**RE: WATER STORAGE IMPROVEMENTS
PLATTE, SOUTH DAKOTA
SPN #16367**

ADDENDUM NUMBER 1

The following modifications are to be made to the specifications for the Water Storage Improvements Project.

Platte Water Tower Logo

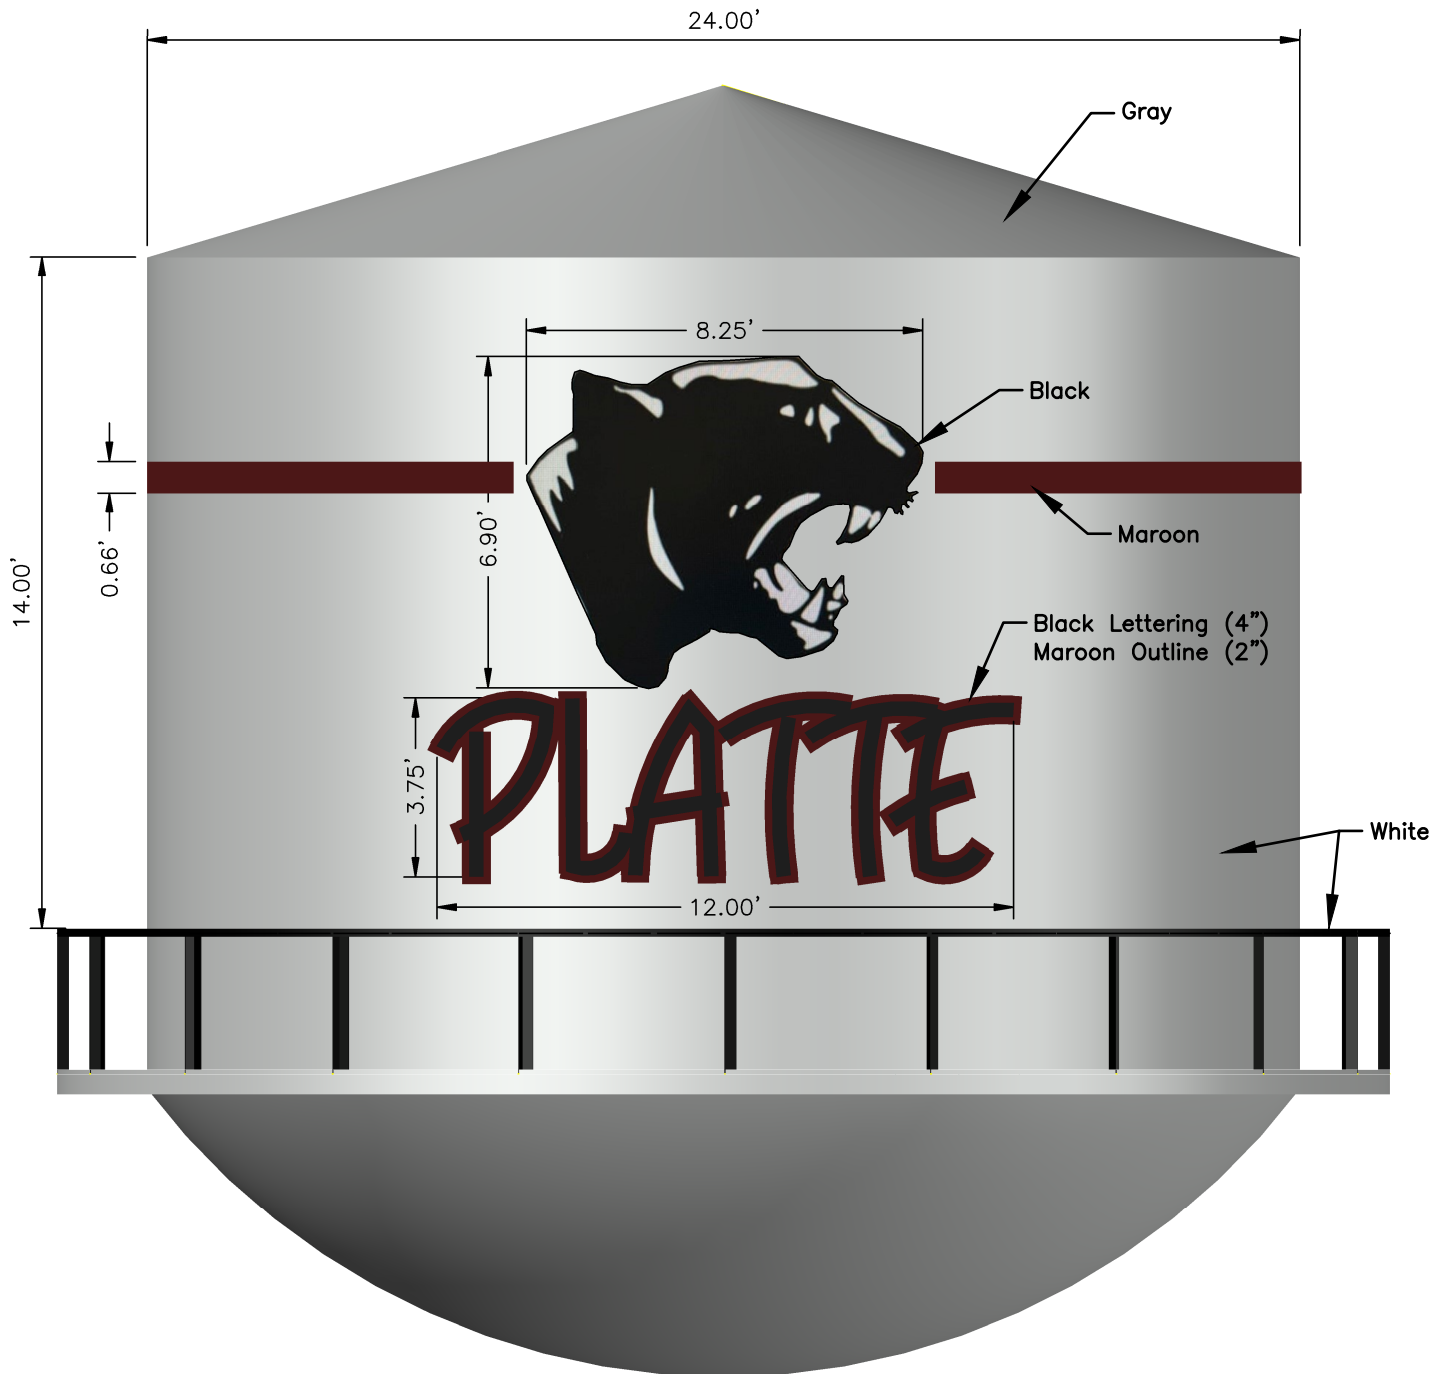
- A. The logo, banner and lettering shall be two coats of Tnemec Series 700, Sherwin Williams Fluorokem HS 100, or approved equal with a DFT of 2.0 to 5.0 mils, each. The logo and lettering shall be placed as shown in Figure A. The logo and lettering shall be placed on two locations which will be determined later. The banner shall wrap completely around the tank as shown in Figure A.
